Federal Motor Vehicle Safety Standards; Occupant Crash Protection

ACTION: Correcting amendment.

SUMMARY: This rule corrects an error in the figure for the removable dash label

Figure 12. Removable Label on Dash.

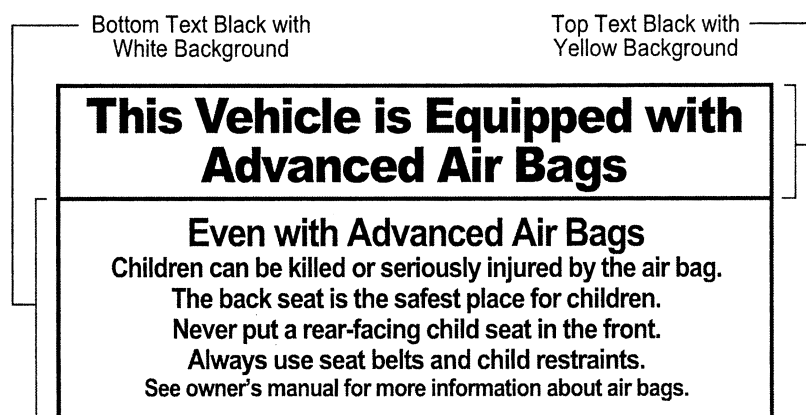
In response to the January 2003 final rule, Honda commented that, "the Removable Label on Dash (Figure 9) that should correspond to the applicable sun visor label was not amended. To avoid confusing or misleading users, the statement '*never put a rear-facing child seat in the front*' should be added in the removable label." The agency agrees that the warnings on the removable dash label and sun visor label should be consistent.

To maintain consistency and conform the dash label to the sun visor label, Figure 12 is added to FMVSS No. 208, which is identical to Figure 9 except that Figure 12 has an additional bullet point stating: "Never put a rear-facing child seat in the front." Maintaining the uniformity of the dash and sun visor labels ensures that users are not confused as to the importance of placing rear-facing child seats in the vehicle's back seat. To further maintain consistency with the sun visor label, the bullet point will not be required on the temporary dash label if the vehicle has no back seat or the back seat is too small to accommodate a rear-facing child restraint.

The removable dash labels required on vehicles certified on or after December 1, 2003, must conform to Figure 12 of FMVSS No. 208. The labels on vehicles certified before December 1, 2003, must conform to either Figure 9 or 12.

(iv) If the vehicle does not have a back seat or the back seat is too small to accommodate a rear-facing child restraint consistent with S4.5.4.1, the label shown in Figure 12 may be modified by omitting the statement: "Never put a rear-facing child seat in the front."

(iv) If the vehicle does not have a back seat or the back seat is too small to accommodate a rear-facing child restraint consistent with S4.5.4.1, the label shown in Figure 12 may be modified by omitting the statement: "Never put a rear-facing child seat in the front."
